REMARKS

I. Drawings

Figure 1

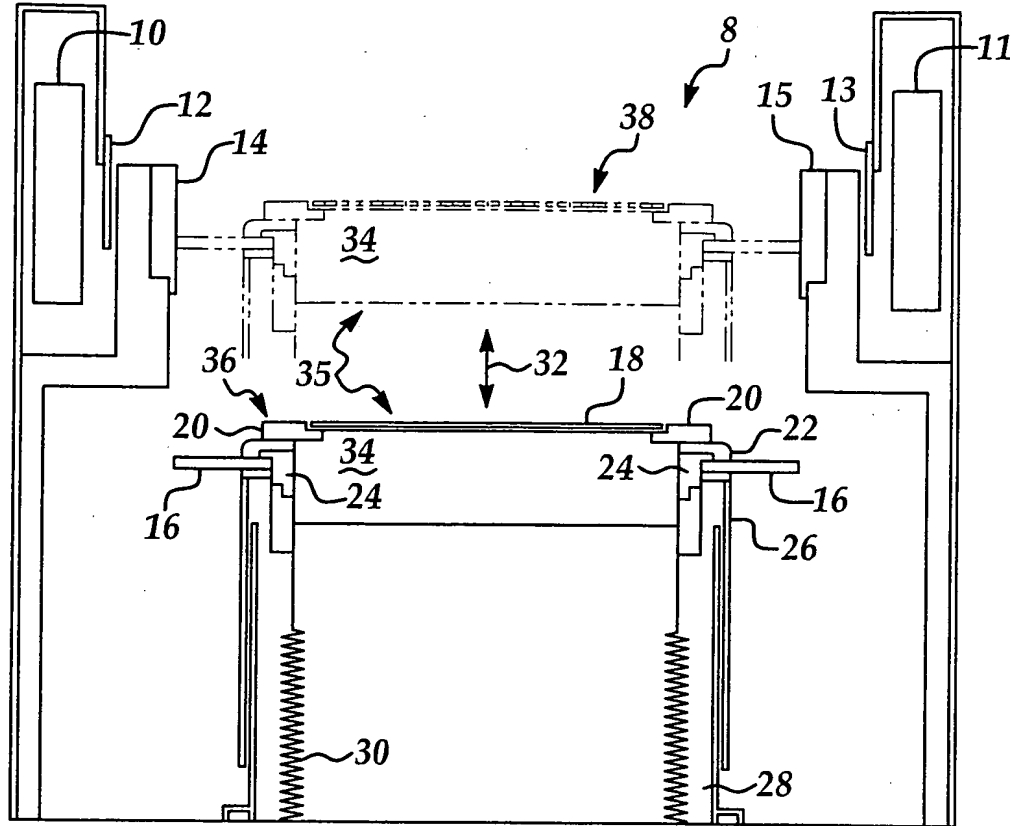
The drawings were objected to by the Examiner as failing to comply with 37 CFR 1.84(p)(4) because the Examiner asserted that reference character "14" has been used to designate both a gauge (citing FIG. 1) and the cover (citing FIG. 2). The Examiner indicated that a proposed drawing correction or corrected drawings are required in reply to the Office action to avoid abandonment of the application. The Examiner further indicated that the objection to the drawings will not be held in abeyance. Applicants are therefore submitting herewith, a proposed drawing correction, which indicates that the old reference numeral "14" shown in FIG. 2 has now replaced with reference numeral "12". Reference numeral "14" has also been added to FIG. 2 to refer properly to the gauge 14 in FIG. 2. Applicants therefore assert that these corrections will overcome the aforementioned objection. Applicants further believe that such corrections do not constitute new matter, but are merely clarifying nature.

The Examiner also objected to the drawings as failing to comply with 37 CFR 1.84(p)(4), arguing that the reference characters "12" and "14" have both been used to designate the cover. The Examiner indicated that a proposed drawing correction or corrected drawings are required in reply to the Office action to avoid abandonment of the application. The Examiner indicated that the objection to the drawings will not be held in abeyance. Applicants have therefore modified FIGS. 1 and 2 as indicated by the proposed drawing corrections to clarify and correct reference numerals "12" and "14". Reference numeral 12 refers now properly to the cover and reference numeral 14 refers now properly to the gauge in FIGS. 1 and 2. Applicants therefore assert that these corrections will overcome the

aforementioned objection. Applicants further believe that such corrections do not constitute new matter, but are merely clarifying nature.

Figure 2

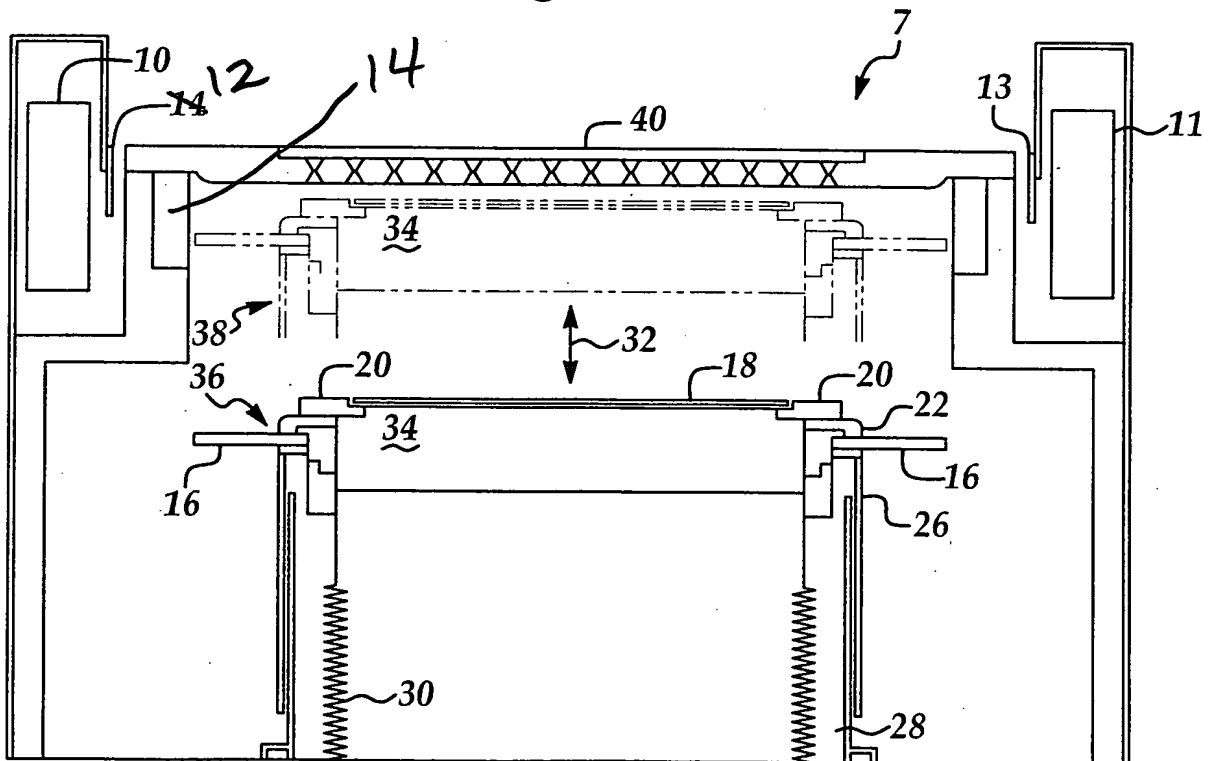
The Examiner additionally objected to the drawings, arguing that the gauge has not been clearly identified in FIGS. 2 and 3. The Examiner argued that a proposed drawing correction or corrected drawings are required in reply to the Office action to avoid abandonment of the application. The Examiner again indicated that the objection to the drawings will not be held in abeyance. Applicants have therefore modified FIGS. 2 and 3 as indicated herein to indicate that the gauge is represented by reference numeral 14 and the cover by reference numeral 12. In FIG. 3, for example, the old reference numeral 14 has now been changed to reference numeral 14 (i.e., see enclosed drawings corrections). Additionally, in order to clarify FIG. 3, the Applicants have amended the specification to point out that reference numeral 74 actually refers to a modified version of gauge 78. It is believed that reference numeral 74 does not need to be changed to reference numeral 14 in FIG. 3 because FIG. 3 essentially represents an alternative embodiment. Applicants therefore assert that these corrections will overcome the aforementioned objection. Applicants further believe that such corrections and amendments do not constitute new matter, but are merely clarifying nature.

The Examiner argued that claims 1, 11 and 21-22 refer to a gauge apparatus and method comprising a gauge for measuring a gap between a baffle plate and a chamber wall, but that it is not clear how this is accomplished. The Examiner argued that it appears that important structures and elements are needed as part of this gauge in order to reach the desired measurements. The Examiner further argued that discrepancies have been found between the figures and the specification, which makes it difficult to understand. For example, the Examiner argued that the specification shows reference element #12 to be a cover. The Examiner also argued that Figure 1 also shows the element 12 as a cover, but that Figures 2 and 3 label the same structure as reference element #14, which according to the specification corresponds to the gauge. The Examiner further referred to FIG. 1, arguing that FIG. 1 discloses element #14 to be the gauge, and that there is no way to identify the gauge in FIGS. 2-3 other than by correlating similar structures in the drawings.

The Applicants respectfully disagree with this assessment. Applicants have submitted proposed drawing corrections herewith, which the Applicants believe clarify the enablement requirement issue raised by the Examiner. Additionally, the

Applicants have amended the specification and claims to clarify. For example, in FIG. 2, the gauge 14 has been added to point out its location proximate to the cover 12, which is now consistent with FIG. 1. Similar corrections have been made to FIG. 3 (i.e., see proposed drawings corrections). Thus, in FIG. 1, 2, and 3, reference numeral 12 now refers to the cover. In FIGS. 1-2, reference numeral 14 refers to the gauge, while in FIG. 3, reference numeral also refers to a gauge (i.e., see amendments to the specification herein), which is a modified portion or modified gauge. Applicants therefore believe that these changes now permit the gauge to be identified in FIGS. 1-3.
